Serial No. 05-457A
ESP/JDH
Docket No. 52-008

DOMINION NUCLEAR NORTH ANNA, LLC
NORTH ANNA EARLY SITE PERMIT APPLICATION
RESPONSE TO NRC QUESTIONS ON JULY 26, 2005 CONFERENCE CALL

Response to NRC Questions on July 26, 2005 Conference Call

Figure 1. Poisson's ratio models with upper and lower bound constraints for Model 2.

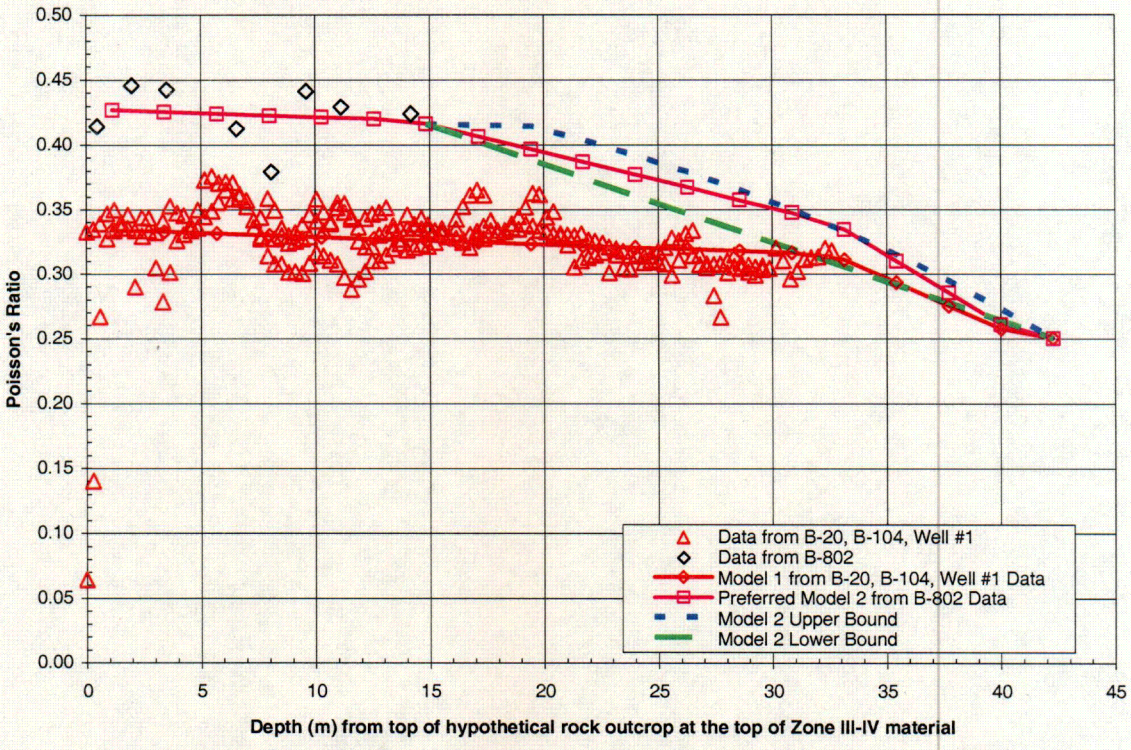
How were Poisson's ratios for Model 2 developed for depths greater than 15m?

Model 2 comprises three linear segments. The first segment [from 0 to ~15m] is the result of a least-squares fit to the available Poisson's ratio data from boring B-802. No S-wave data are available for this boring at greater depths. The end of the deepest [third] segment is constrained to have a Poisson's ratio of 0.25, appropriate for rock at the top of the Mid-Continent crust [EPRI (1993), Reference 2].

The second and third segments of Model 2 are defined to give a simple Poisson's ratio model bounded by two constraints: 1) the model should not cross the Model 1 representation of Poisson's ratio [as a simple two-segment model would], and 2) the corresponding P-wave velocity should not significantly exceed a value of 4,900 m/sec [the P-wave velocity of the rock at the top of the Mid-Continent crust] for depths shallower than 41.0 meters.

If Model 2 had been defined by a single straight line segment from the end of the fit to available data at 15m to the Poisson's ratio value of 0.25 at 41m depth this model would have intersected, and at places, dropped below Model 1. Defined in this manner, Models 1 and 2 would have differed negligibly from depths of ~30m to 41m. Because it was of interest to consider the full range of epistemic uncertainty in the development of the V/H ratios, this convergence of Models 1 and 2 was assessed to be undesirable, establishing a lower bound for the Poisson's ratios of Model 2.

An upper bound to Poisson's ratio Model 2 was defined by the values of Poisson's ratio resulting from fixing the P-wave velocity to have a constant value of 4,900 m/s near the end of the B-802 data at ~15m to the depth of 41m. A shallower slope model of Poisson's ratio would then imply P-wave velocities greater within the rock column than at its bottom.

Figure 1 shows Model 2 Poisson's ratios and the upper and lower bounding constraints specified.

Figure 2. **Preferred V/H mean and fractiles ratios, using weights of 0.25 and 0.75 for Poisson's ratio Models 1 and 2.**

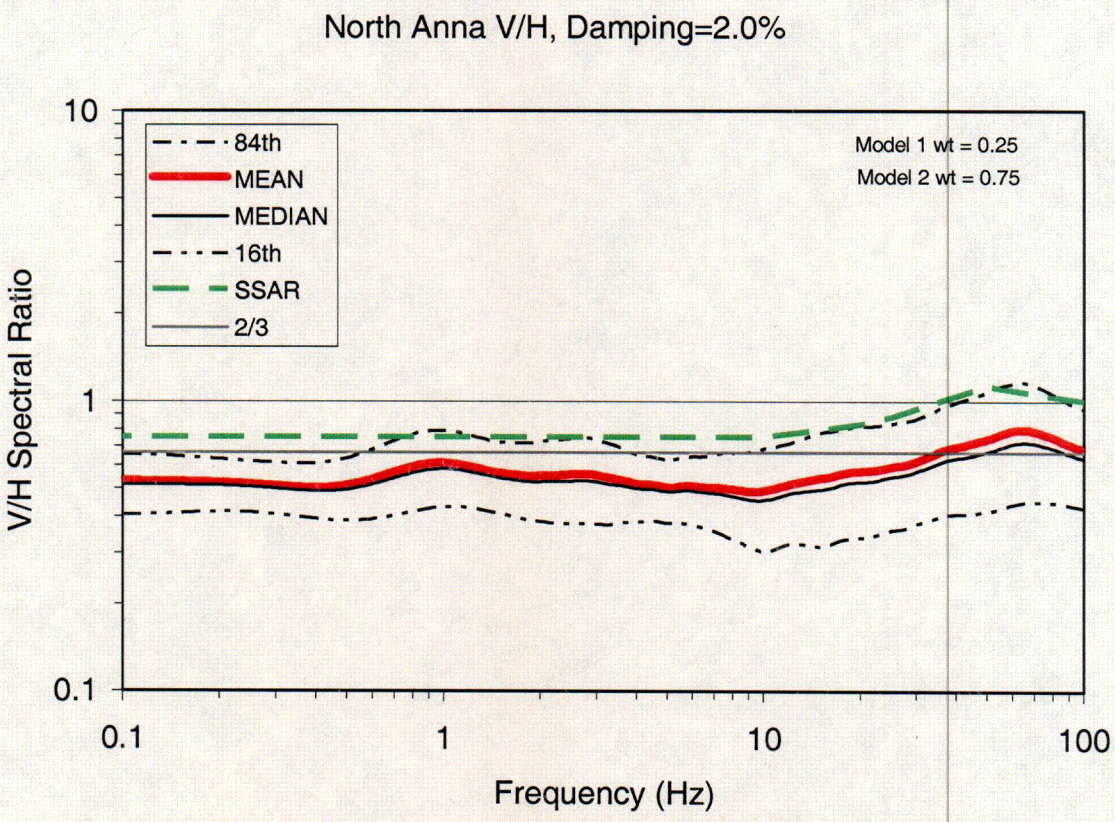
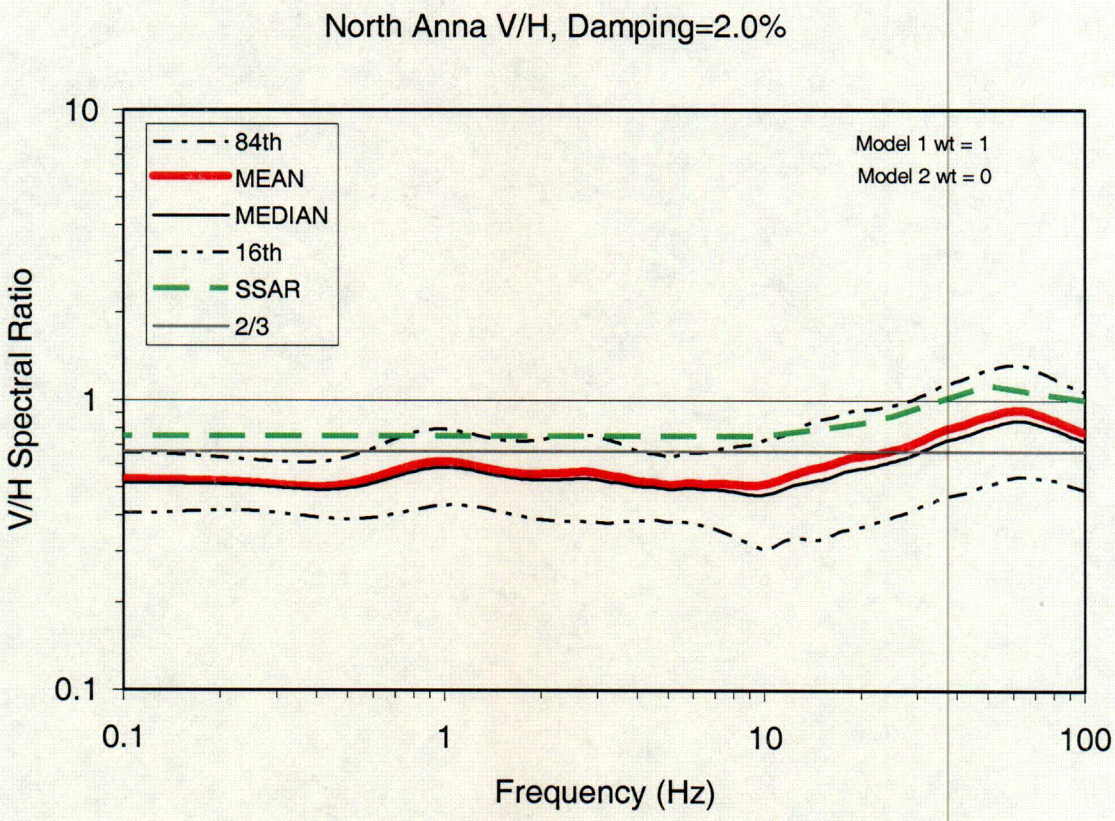
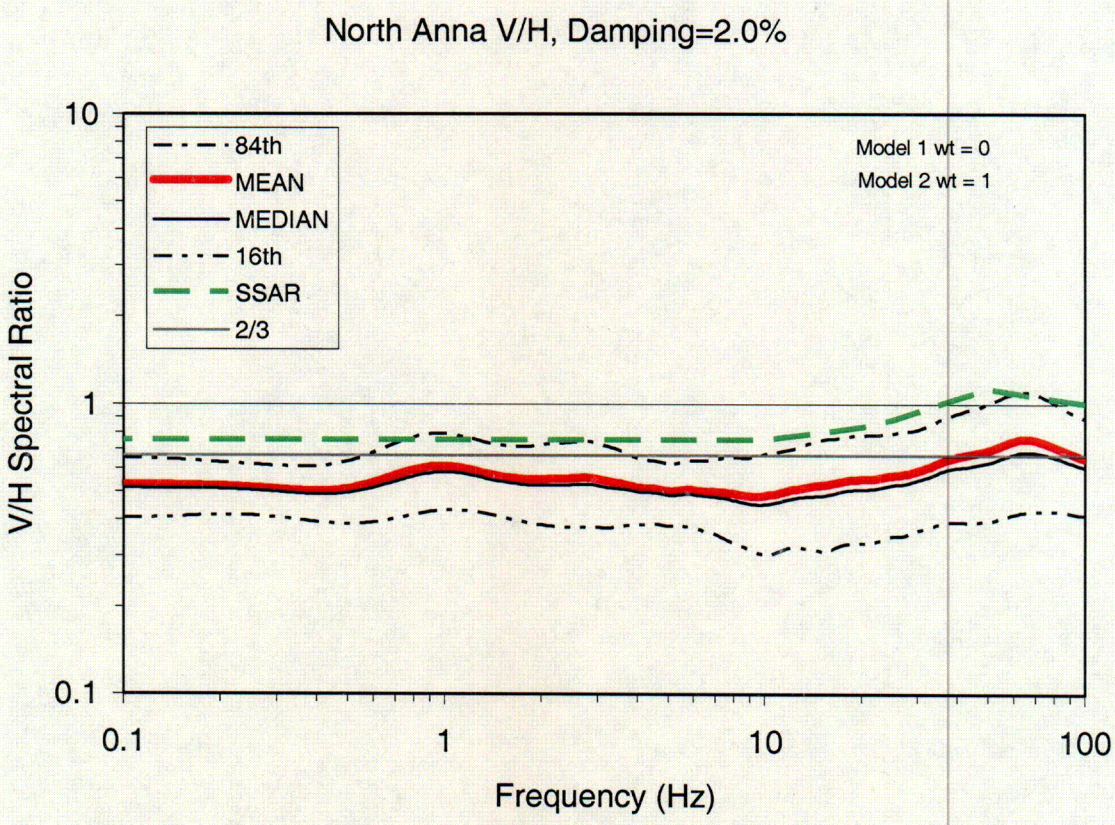
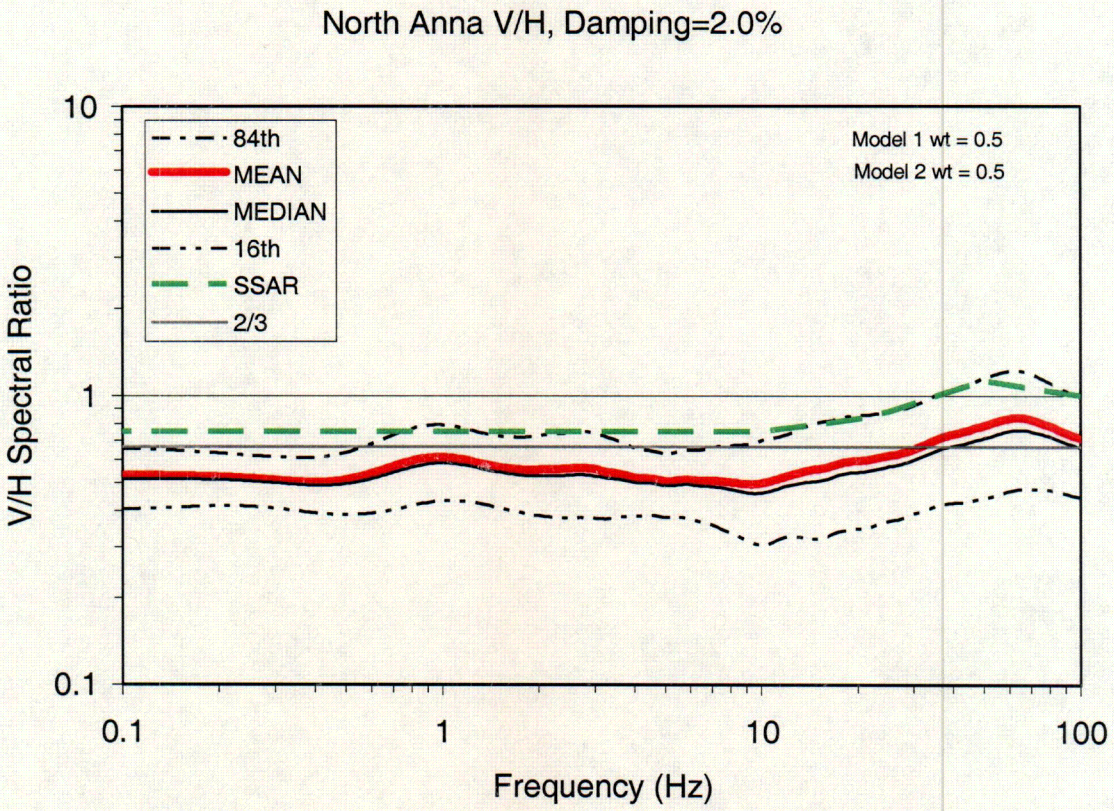
What are the effects on the resultant V/H ratios of considering different weights between Model 1 and Model 2?

Figure 2 shows the resulting V/H ratios for the mean and various fractile results where the weights of 0.25 and 0.75 have been considered for P-wave Models 1 and 2, respectively. A graphical measure of the sensitivity of V/H ratios to the weights assigned to Poisson's ratio Models 1 and 2 is provided in several additional plots. In Figure 3, Model 1 has been given a weight of 1.0 and Model 2 a weight of 0.0, putting complete confidence in the older, original site geotechnical investigation data. In Figure 4, Model 2 has been given a weight of 1.0 and Model 1 a weight of 0.0, putting complete confidence in the recent ESP subsurface investigation data. Finally, both models have been given equal weight in Figure 5.

While the 0.25 Model 1and 0.75 Model 2 weight distribution is preferred, the effect on V/H ratios is modest over the entire range of possibility and does not affect the fundamental conclusion that the V/H ratios given in NUREG/CR-6728 for hard rock and used in SSAR Table 2.5-27A for development of the vertical SSE spectrum are appropriate.
